PlanGrid Task Report - Jan 23, 2025

#108 [EXHA 509] [NEW] Grease exhaust duct Paint.....	2
#107 [CNTL 508] [NEW] Controls labeling.....	3
#106 [UNIT 504][NEW] Equipment Fresh Air Tempering	5
#105 [UNIT 999][NEW](MISC) AC-1 OA Damper Feedback.....	6

L05138 Charlotte Hall FSU (MD)

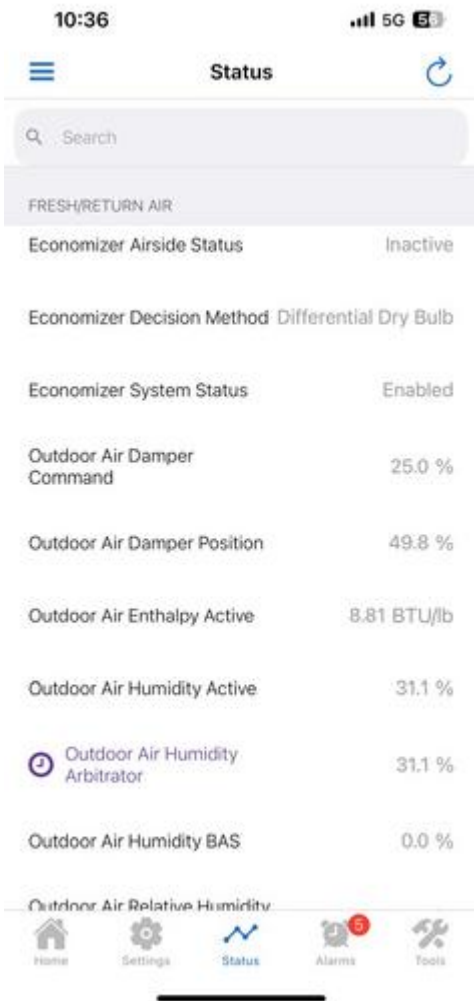
AC-1 OA damper was not functional on arrival. The connector was damaged from the factory, MC corrected. Damper is now operating properly and goes to correct setpoint, however, damper feedback indicates damper is at 49%, when it is only at 25%. While damper is operating properly, recommend this issue is addressed while unit is under warranty.
